ADDENDUM NO. 2

Rochester City School District

Dr. Walter Cooper, School #10

February 28th, 2018

SITE MATERIALS PLAN

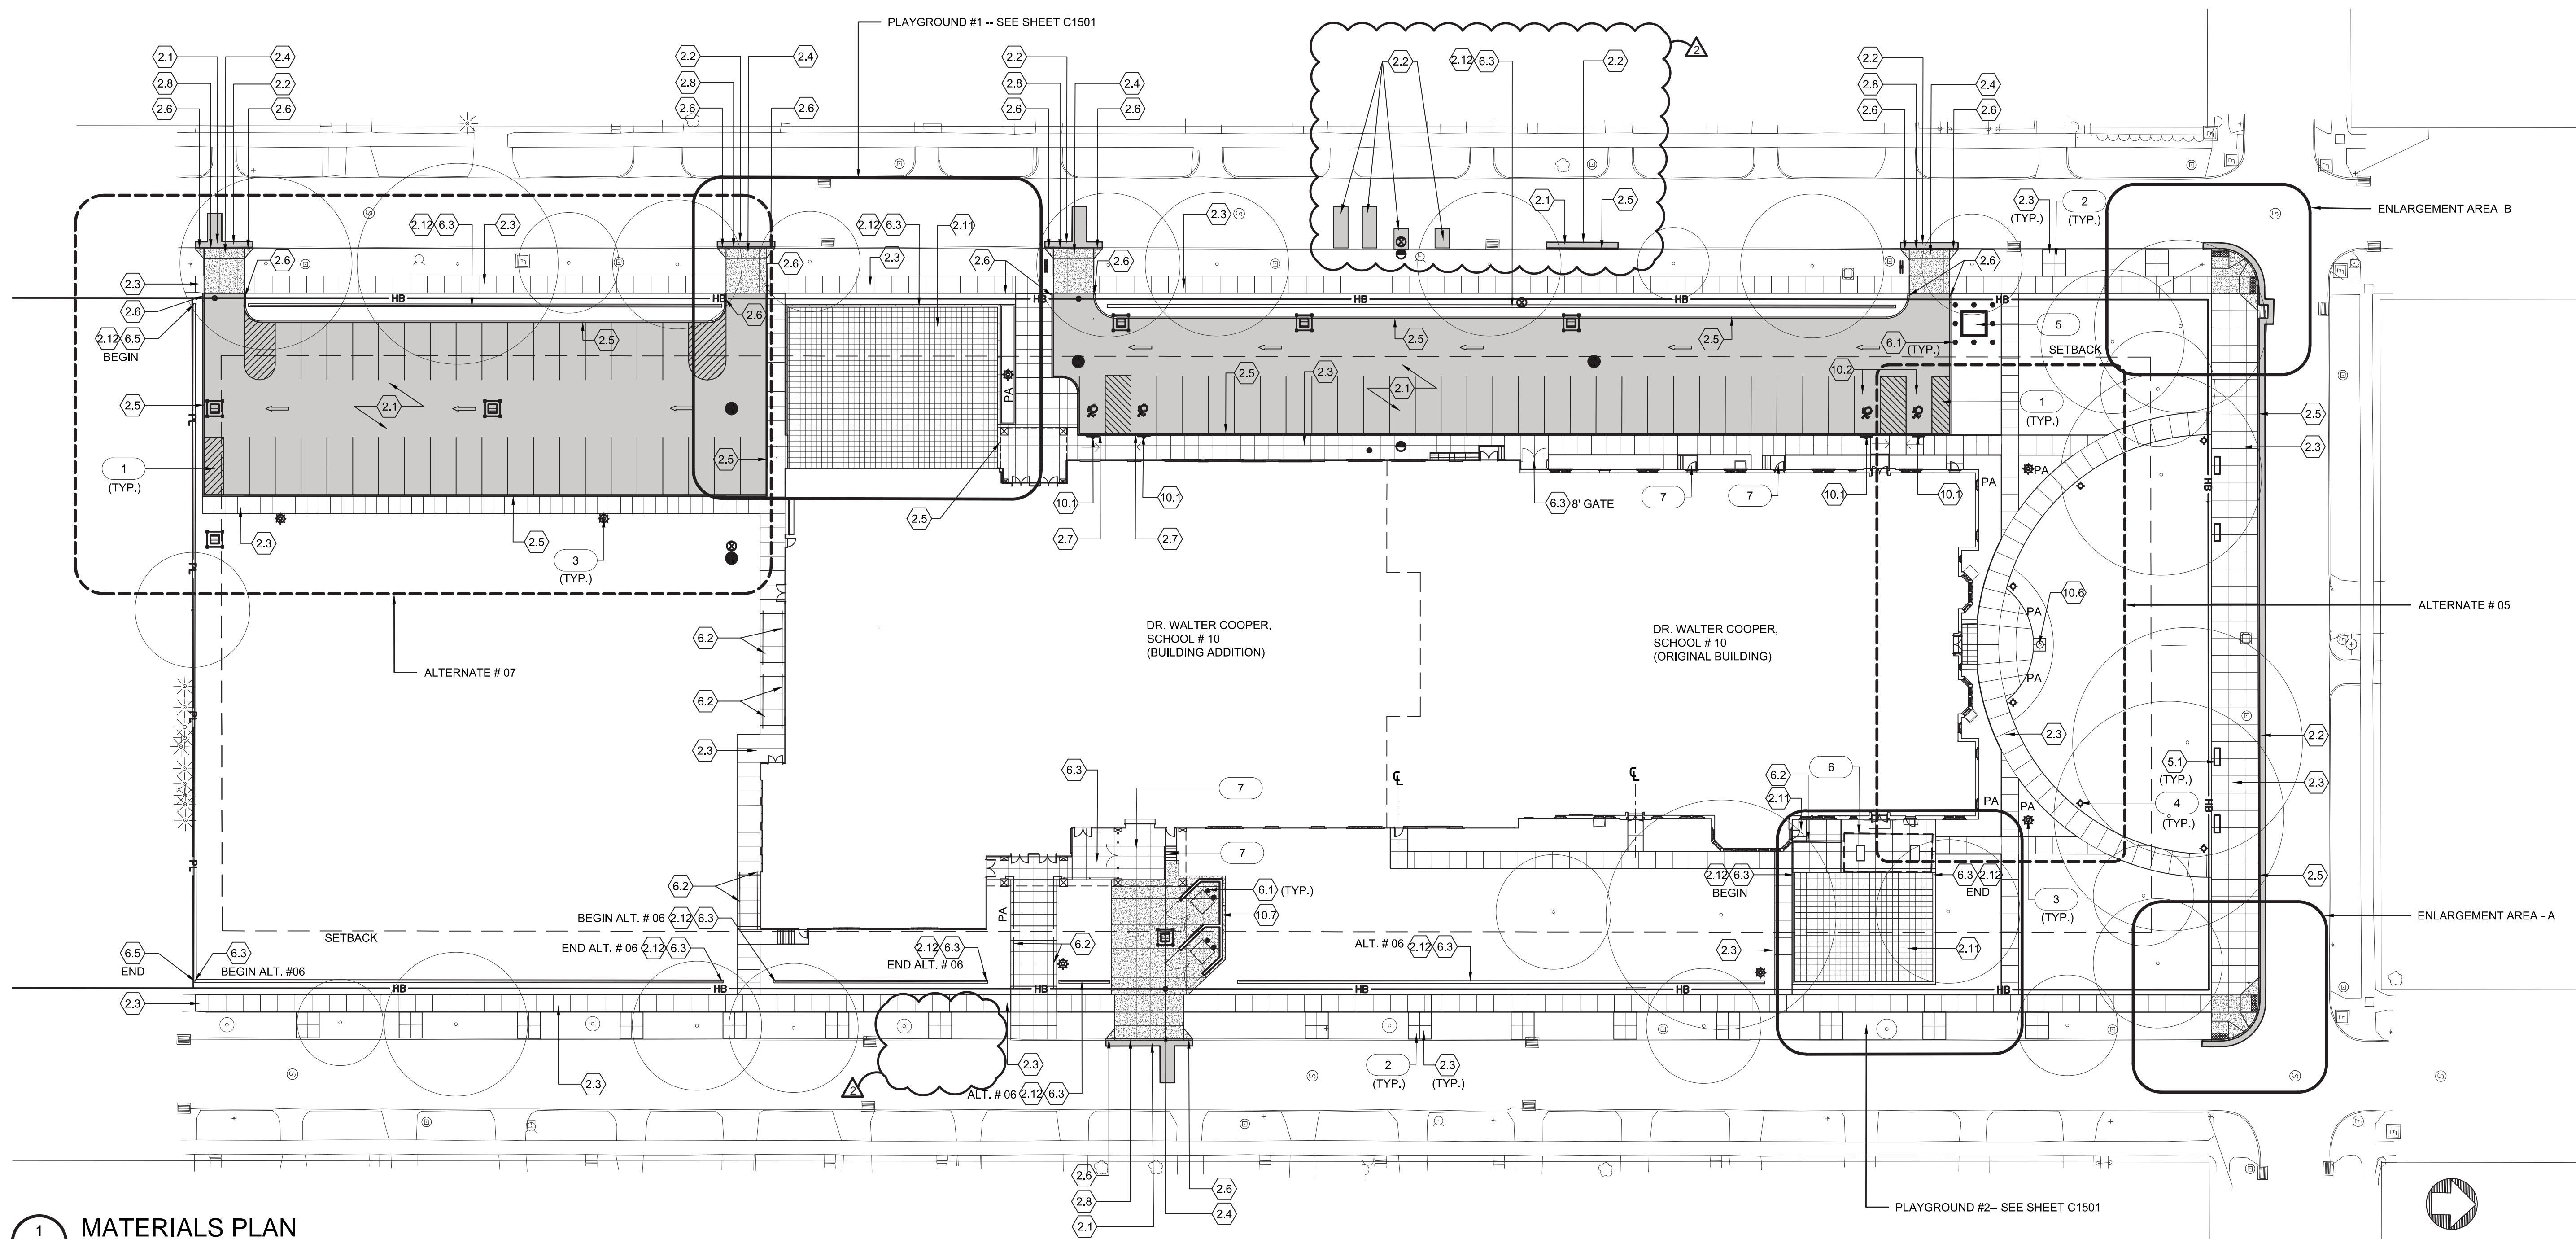
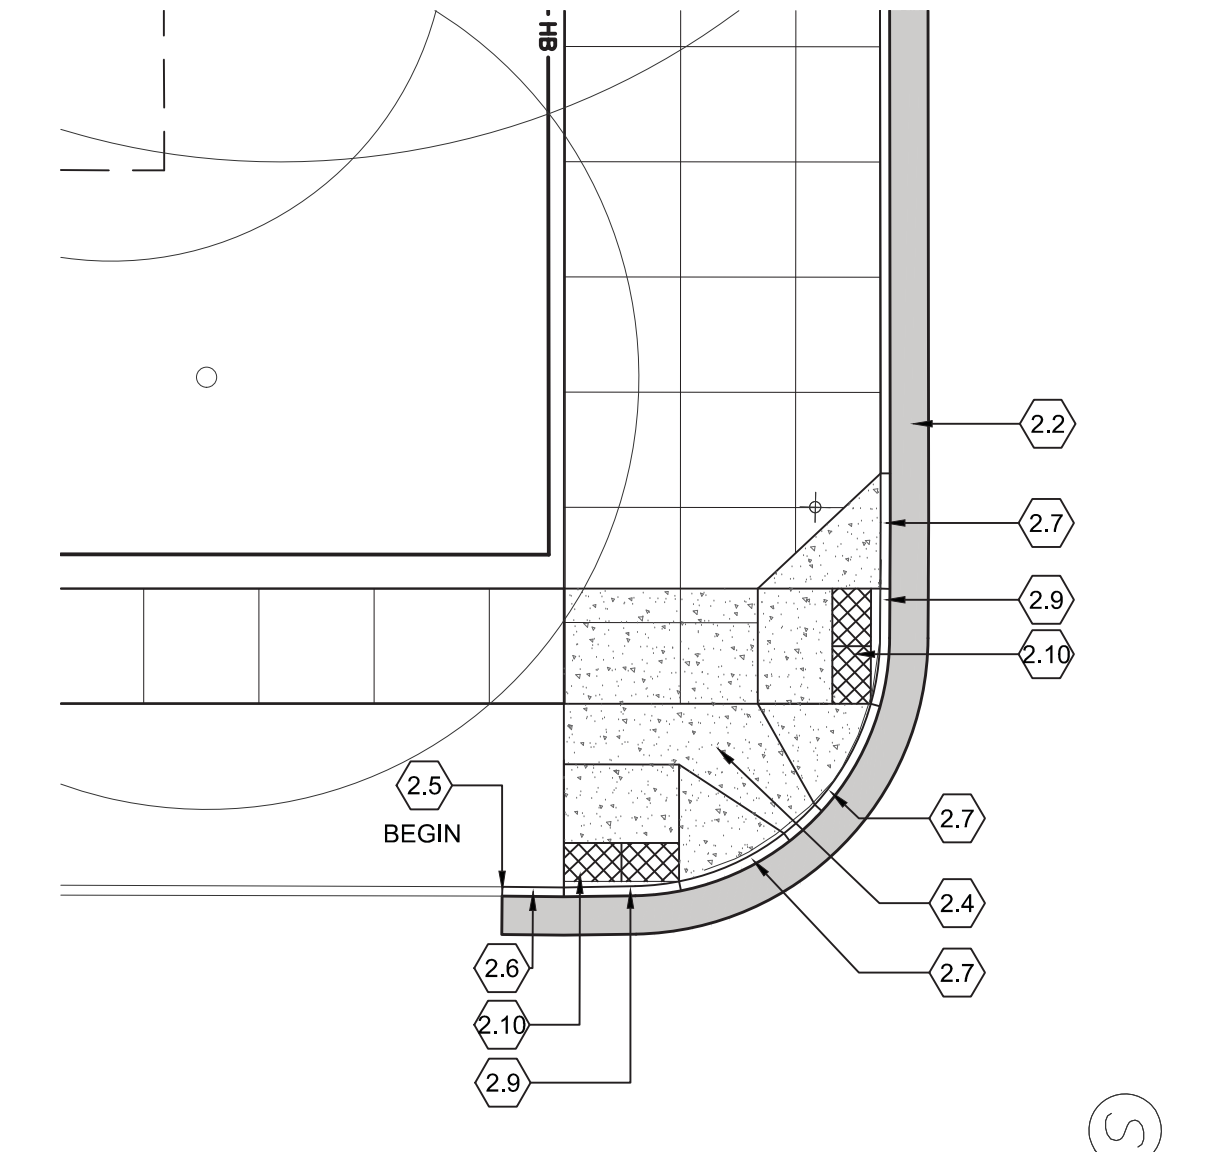
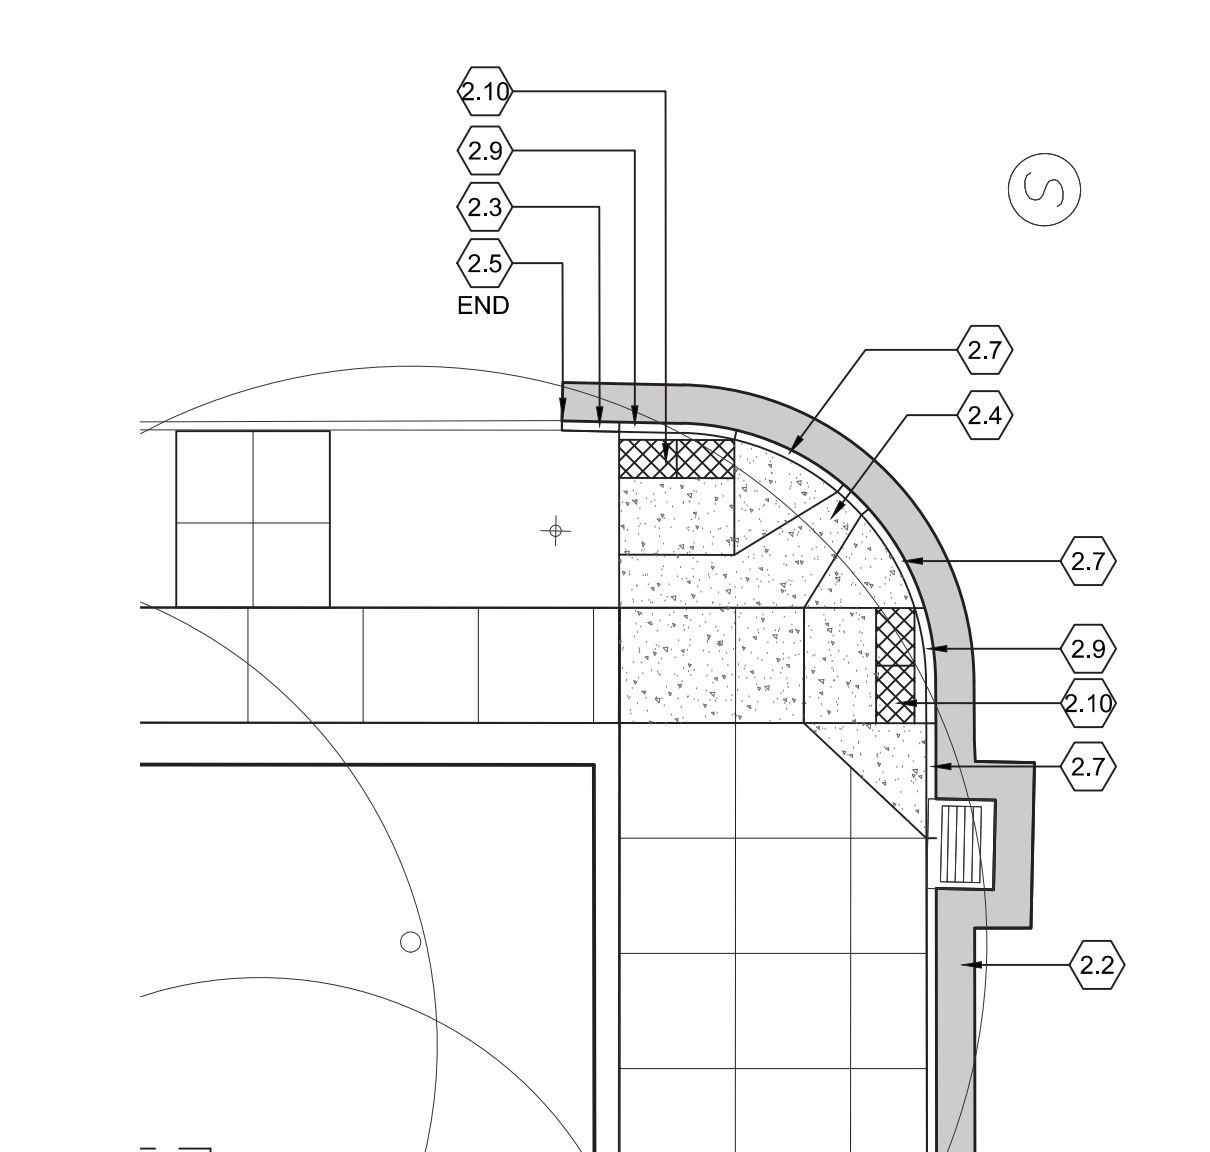
Item AD2-12 **REPLACE** drawing in its entirety with attached “C1101 – SITE MATERIALS PLAN.” Remove pavement and curb restoration where existing utilities will be abandoned in the ROW.
